**WHITE LAKE TOWNSHIP
INTER-OFFICE MEMORANDUM
COMMUNITY DEVELOPMENT DEPARTMENT**

**SUBJECT: Culver's
Preliminary site plan approval**
Property described as parcel number 12-20-276-035, located on the north side of Highland Road (M-59) and west of Bogie Lake Road, with a project area on the parcel consisting of approximately 1.69 acres, currently zoned (PB) Planned Business District.

RE: Culver's- Preliminary Site Plan Review – 2nd Review

RE: Culver's
Preliminary Site Plan – Review #2

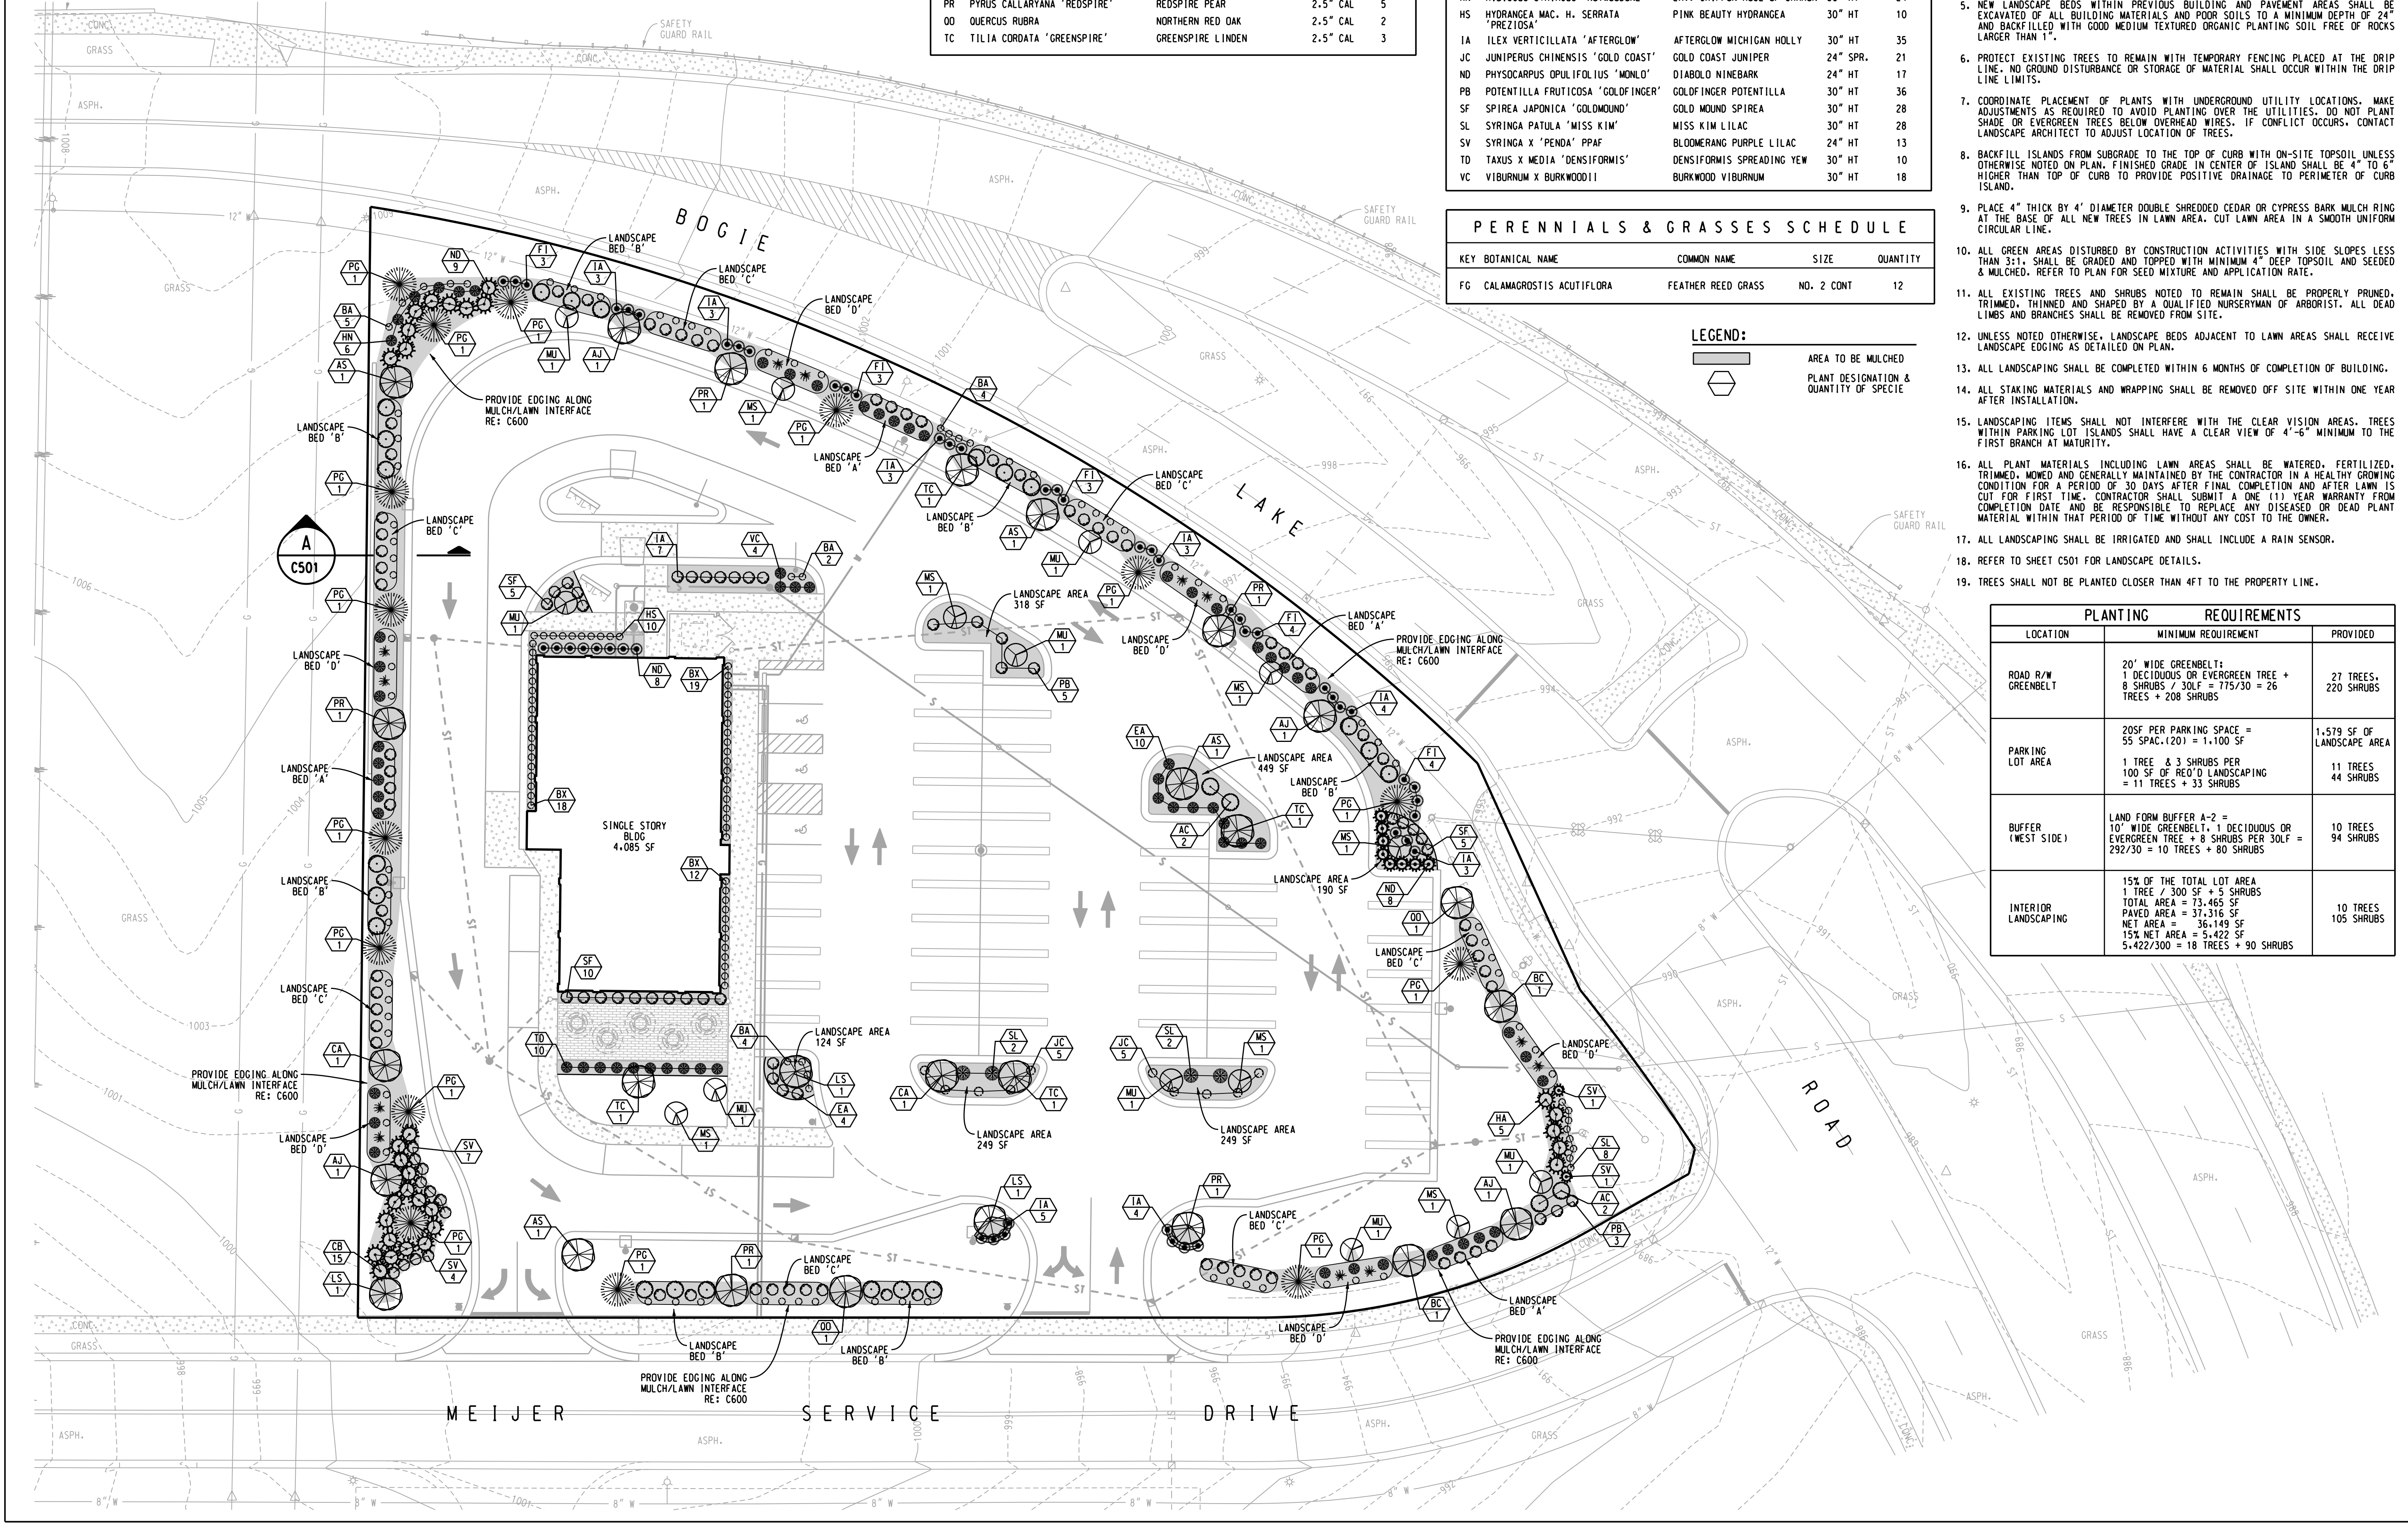
- x) *Sheet C500- There are several locations where proposed trees are shown too close to proposed sanitary sewer, water service, and storm sewer. Please provide a minimum of 10' horizontal separation between trees and these utilities. We have attached a red lined copy of this plan sheet for exact locations. Comment addressed. Landscape plan has now been revised. All proposed trees are now shown a minimum of 10' away from proposed sanitary sewer, water service, and storm sewer.*

- **The Planting Requirements Table on Sheet C500 shall be revised. The minimum requirement listed for the west side buffer is incorrect. A greenbelt 10 feet in width planted with 1 large deciduous or evergreen tree and 8 shrubs for every 30 linear feet is required. Revise accordingly. (Comment partially addressed. While the greenbelt requirement has been added, the following wording still needs to be removed: “Land Form Buffer A-2 =”).**
